Subject: Pre-App Notes | P-21-0135 Normandy Heights

CONCEPT SITE PLAN II

PROJECT: P-21-0135/NORMANDY HOMES

PROJECT DESCRIPTION (as provided by applicant): Second pre-app (original P-20-0034). Confirm sewer capacity at Shaw Rd, verify ROW dedication accuracy, verify frontage requirements along Shaw Rd, revised layout review.

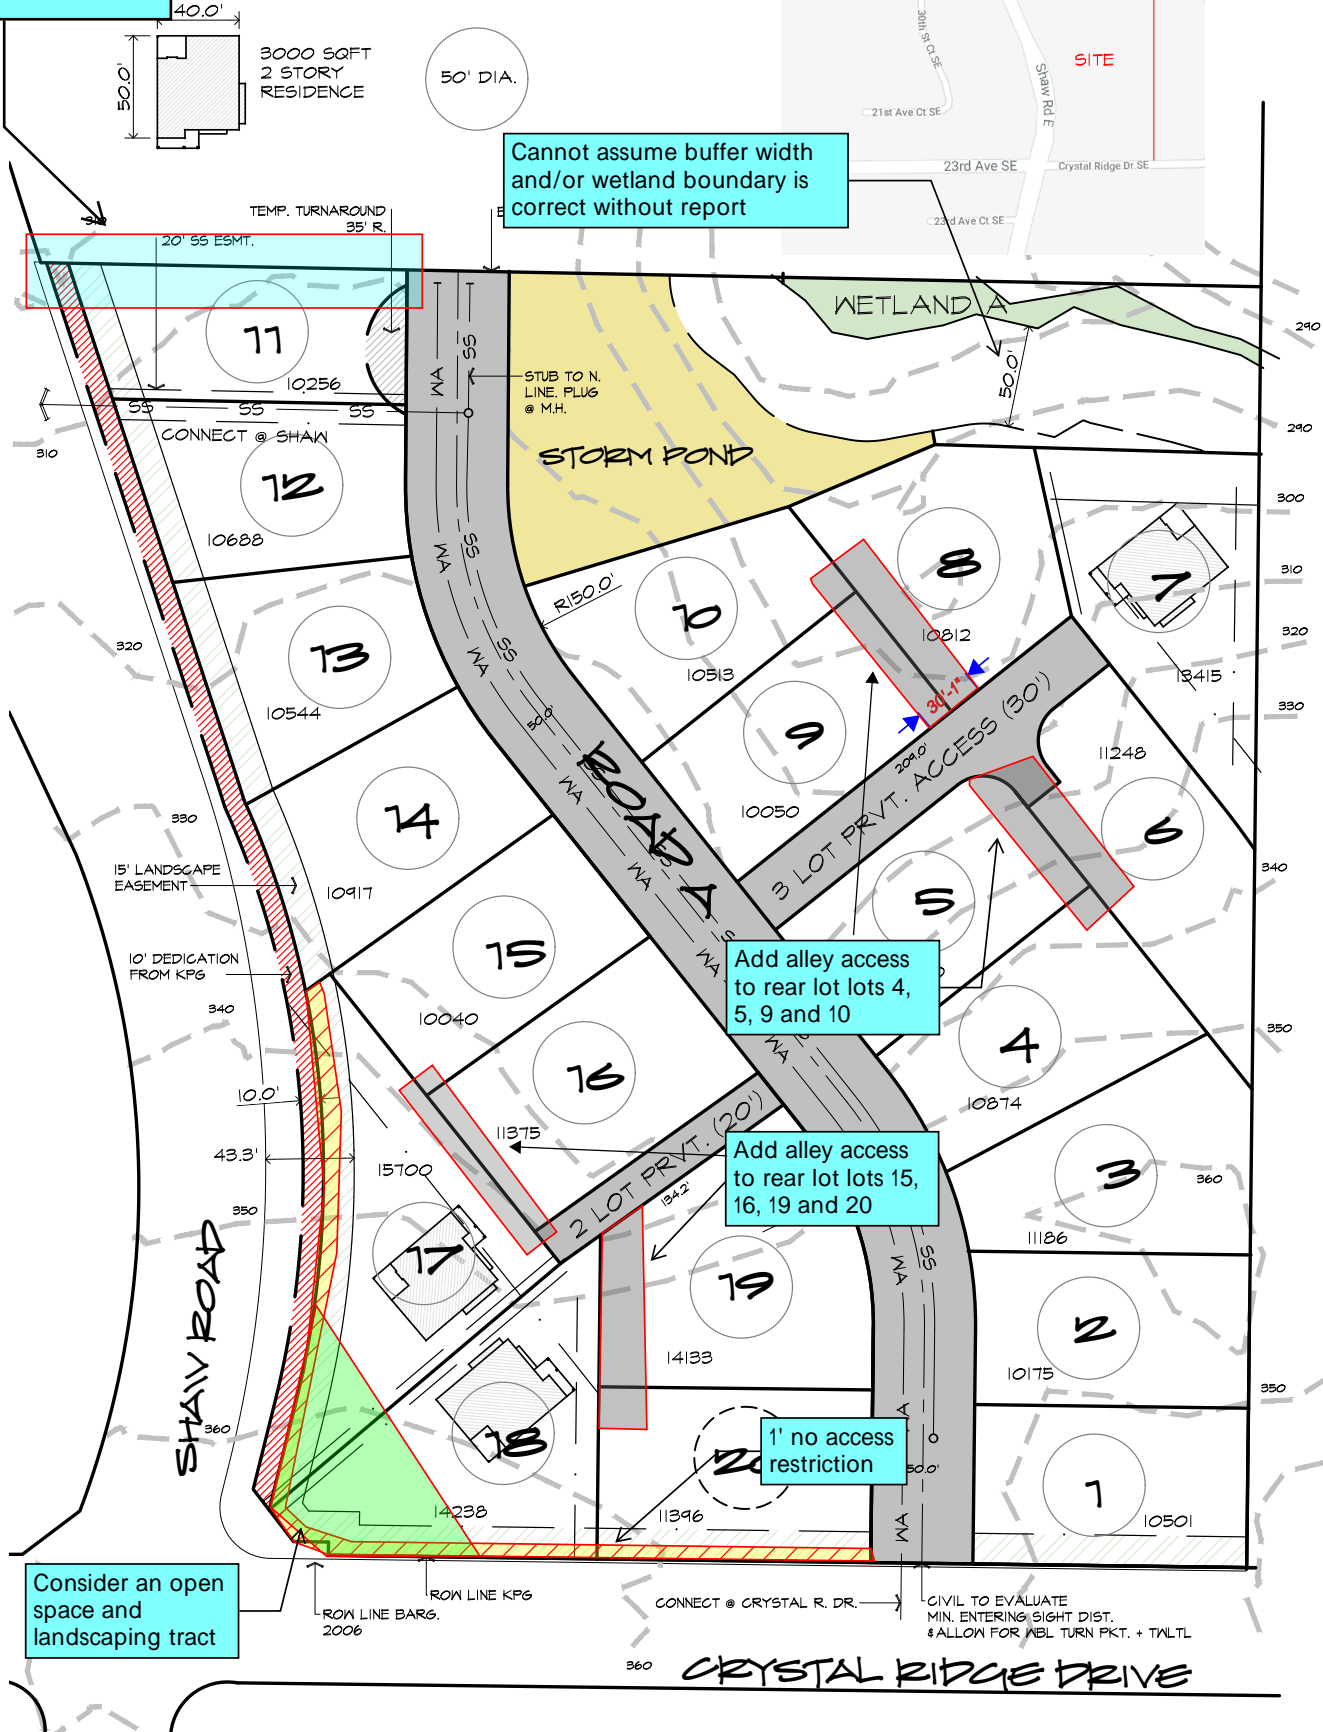
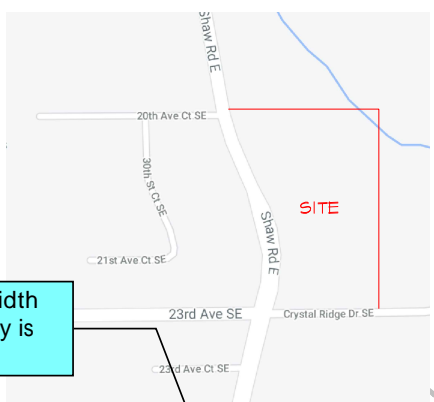
Add ROW alignment for future intersection at 20th & Shaw

Cannot assume buffer width and/or wetland boundary is correct without report

Add alley access to rear lot lots 4, 5, 9 and 10

Add alley access to rear lot lots 15, 16, 19 and 20

1' no access restriction

Consider an open space and landscaping tract

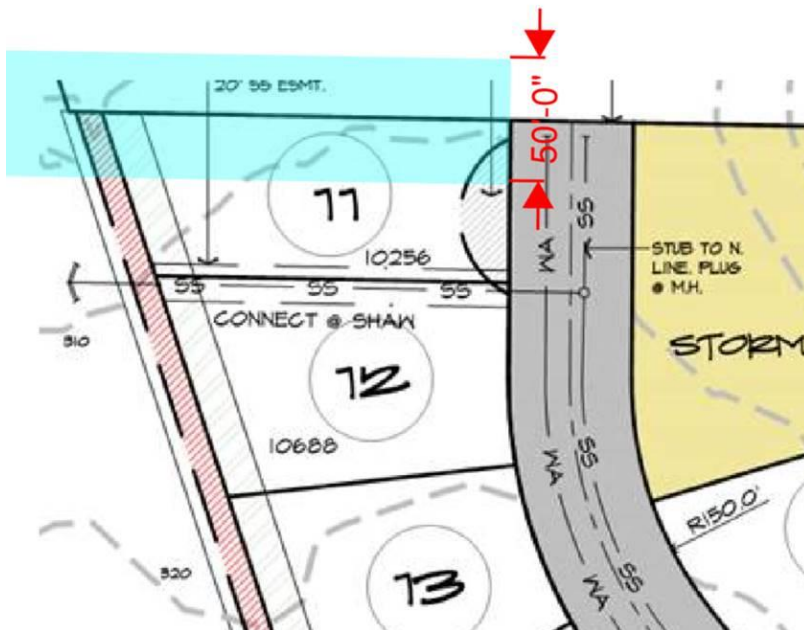
- City is still working on the final alignment & elevations for the future Shaw Rd section. North of 23rd, the future roadway section will have spiral transitions and will likely be superelevated.

- Shaw Rd frontage improvements and ROW dedication will qualify for traffic impact fee reimbursement per the City's "Rate Study for Impact Fees for Roads". Coordinate with the City's Engineering Dept regarding the extent and scope of reimbursement.
